ADDENDUM NUMBER: ONE

**PROJECT: RCMP RTM TRANSPORT STAFF BUILDING,
REGINA, SK.**

This Addendum forms part of the Contract Documents and amends the original Drawings and Specifications dated 2016-01-14, previous Addenda if applicable and as noted below. This Addendum consists of 5 pages and attached Specification Sections and Drawings as listed below.

DEMO PLAN

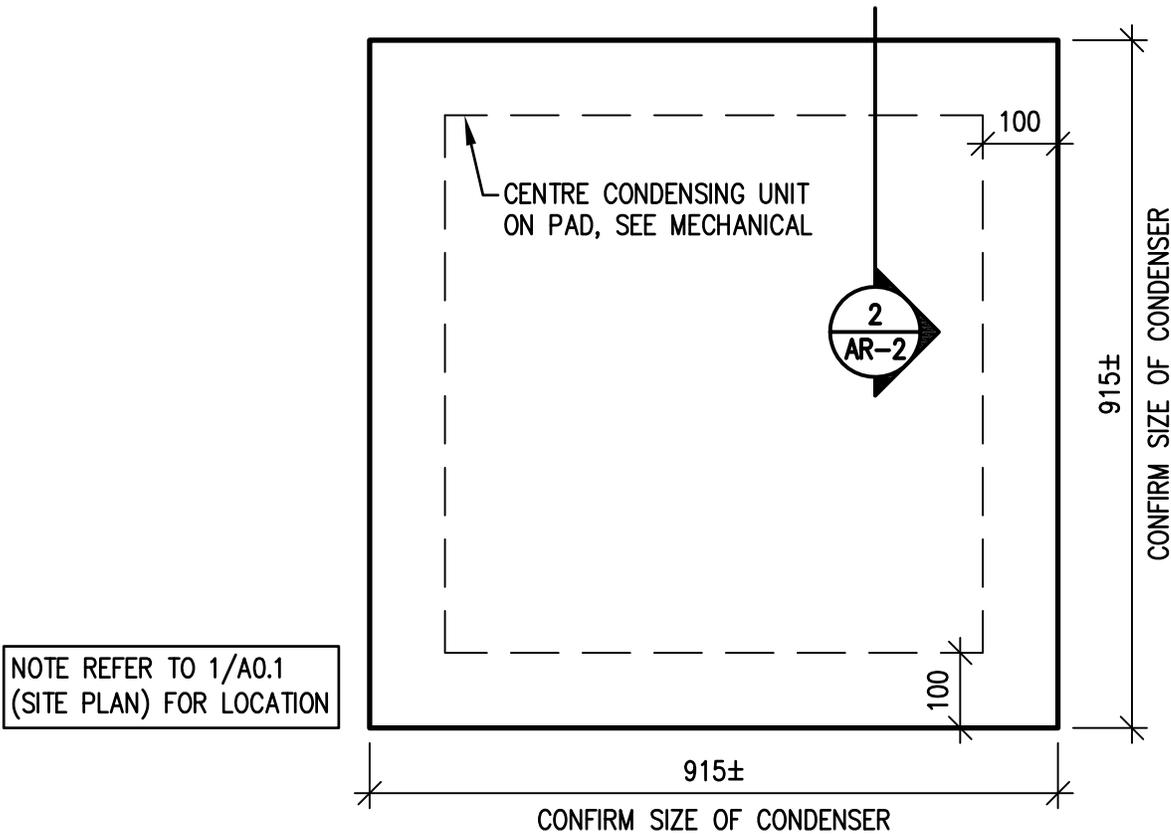
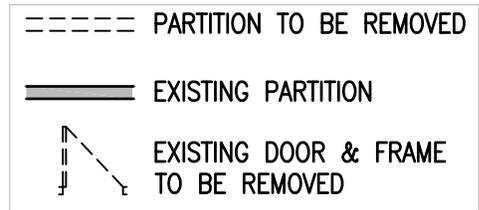
- .1 Revise drawing as per AR-1 attached to this addendum.

- .5 Q: Drawing 2/A1.2 indicates new walls around rooms 105, 106, and 110, however the demolition drawing 1/A1.1 does not indicate for these to be removed. Please clarify the extent of demolition and new walls.
A: Refer to AR-1 for clarification on demolition.

- .6 Q: Demolition drawing 1/A1.1 indicates all exterior doors are to remain however the specifications and drawing A1.2 indicate they are to be replaced. Is the demolition and disposal of these doors included in the scope?
A: Refer to AR-1 for clarification on demolition.

- .7 Q: Specification section 02 41 13 – Part 1.4.3.1 indicates some items are designated for salvage. Besides the vinyl wallboard, is anything else required to be salvaged? (doors, hardware, windows, etc.)
A: Refer to AR-1 for clarification on salvaged material.

NOTE: SALVAGE WINDOWS, DOORS, FRAMES & HARDWARE. TURN OVER TO OWNER.

CONCRETE PAD PLAN

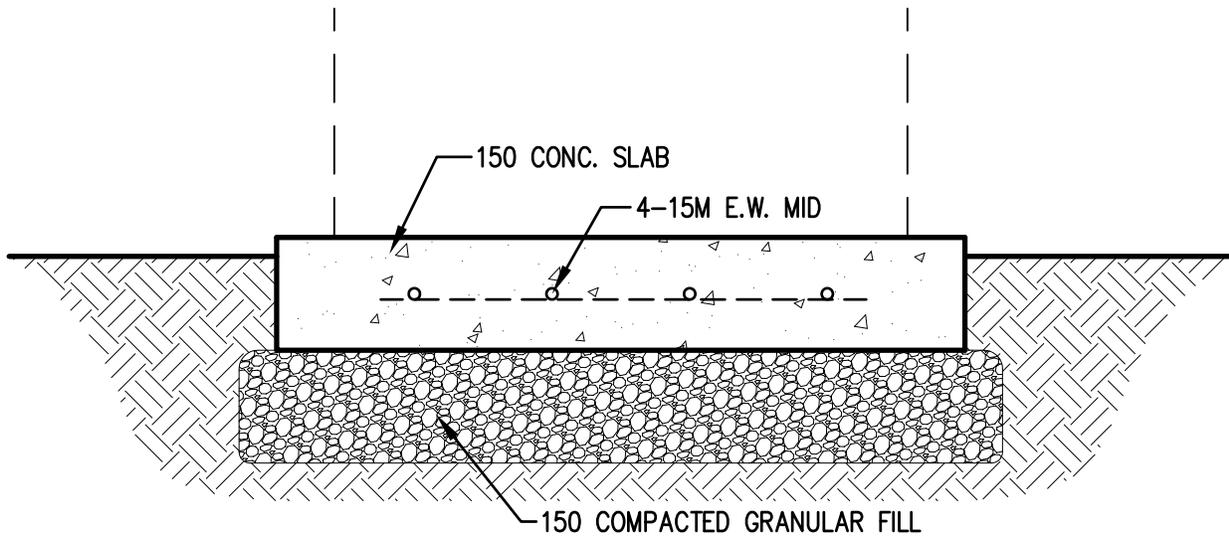
- .1 Drawing A0.1, detail 1: Refer to AR-2 attached to this addendum for construction of the concrete condenser pads.

- .8 Q: Detail 2/M1.1 indicates the condensing units are to be mounted on a concrete base. Are concrete pavers acceptable or is a cast-in-place pad required?
A: Provide cast in place pad. Refer to AR-2 for condenser pad detail.
